# AGENDA

## DEVELOPMENT DETERMINATION PANEL MEETING

**WEDNESDAY 10 FEBRUARY 2021**

**MOD2020/0498 - 70 LAUDERDALE AVENUE, FAIRLIGHT -  
MODIFICATION OF DEVELOPMENT CONSENT DA2020/0092  
GRANTED FOR DEMOLITION OF EXISTING STRUCTURES,  
CONSTRUCTION OF TWO (2) SEMI-DETACHED DWELLINGS  
AND TORRENS TITLE SUBDIVISION OF ONE LOT INTO TWO**

Figure 1: Height of Building Variation

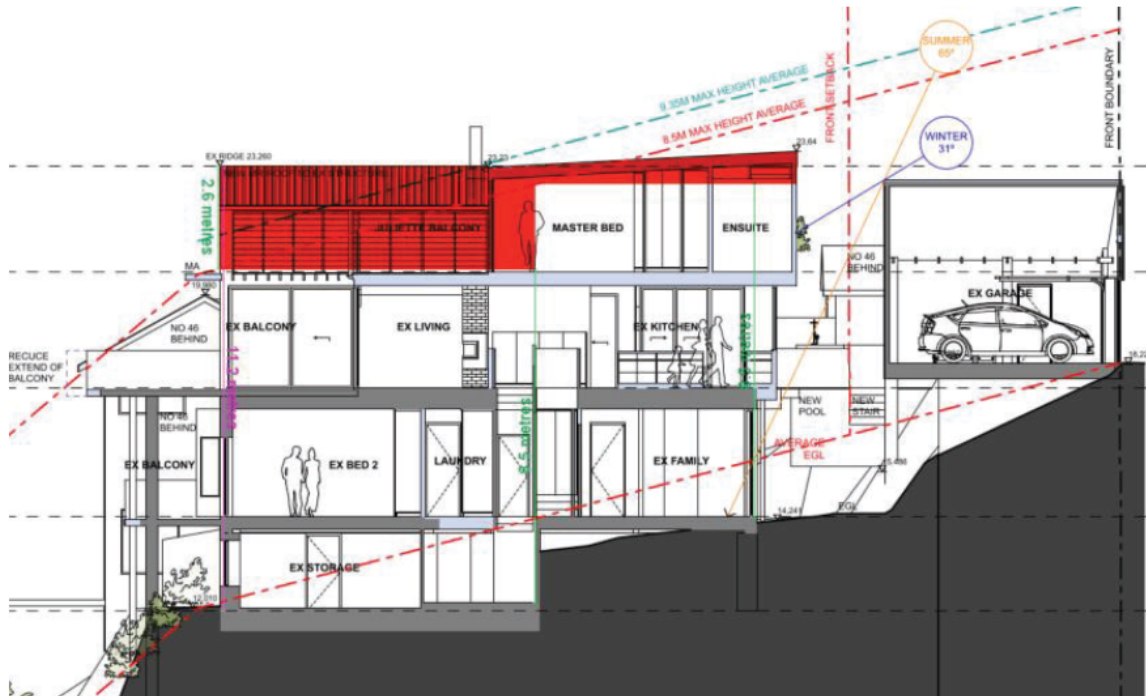
##### Description of non-compliance:

Development standard:	Height of buildings
Requirement:	8.5m
Proposed:	11.2m
Percentage variation to requirement:	31.8%

**Figure 1: Driveway access**

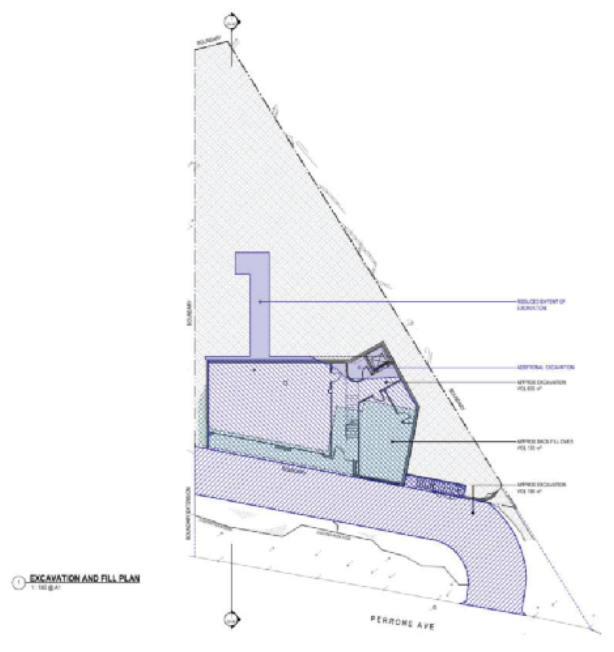
Comment: Council's Traffic Network Team and Development Engineers assessed consider the adjusted levels of the driveway acceptable and raised no issues subject to condition(s).

As demonstrated in figure 1 below the driveway does not prevent any future driveway/access from Peronne Avenue from property 2A Russell Street (which has current access off Russell Street), nor interfere with the existing driveway access for 64 Peronne Avenue or potential access to the current vacant site at 62 Peronne Avenue.

It is considered that this issue does not warrant refusal and/or further amendment via condition (s).
